File Number	PLVAR-2510-0013				Christian Hu chuelsman@	elsman, Oduluthmn.gov
Туре	Variance	from Shoreland Setbacks	Planning Co	ommissi	on Date	November 12, 2025
Deadline	Applicat	ion Date	October 8, 2	2025	60 Days	December 7, 2025
for Action	Date Ext	ension Letter Mailed	October 30,	2025	120 Days	February 5, 2026
Location of Su	bject	800 Railroad St				
Applicant	Donald H	olm Construction	Contact Max Holm		olm	
Agent			Contact			
Legal Description		010-0200-01100				
Site Visit Date		October 29, 2025	Sign Notice	Date	(October 28, 2025
Neighbor Lette	er Date	October 22, 2025	Number of	Letters	Sent 3	}

Proposal

The applicant proposes to construct an exterior spa deck, attached to the interior pool area, 17.5 feet off the existing building. Because the building face is 25' from the seawall, this would be 12.5 feet from the Ordinary High Water Level (OHWL).

Recommended Action: Staff recommends that Planning Commission deny the variance.

PLANTING AREA CROSS-SECTION SCALE: NOT TO SCALE

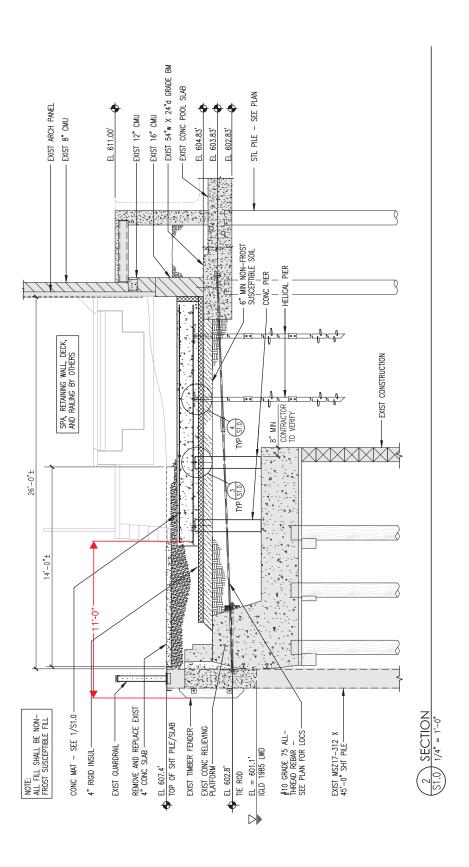
- 9) Standards for variances in shorelands
 - The applicant has submitted details to mitigate the impacts to shorelands from the addition of impervious Runoff from this site runs downhill away from the exterior spa deck, into drain tile and daylights, through the elevated wall to infiltrate to the planting area to the east and west. Staff recommend that any approval of this variance be conditioned such that a mitigation plan with native plantings in the rain gardens, designated to infiltrate water from the proposed deck, is submitted to the Land Use Supervisor prior to approval of a building permit.

While there is existing seawall, there is already very limited vegetation on this lot and this deck will reduce that. Have they proposed mitigation for adding additional impervious surface within the shore impact zone?
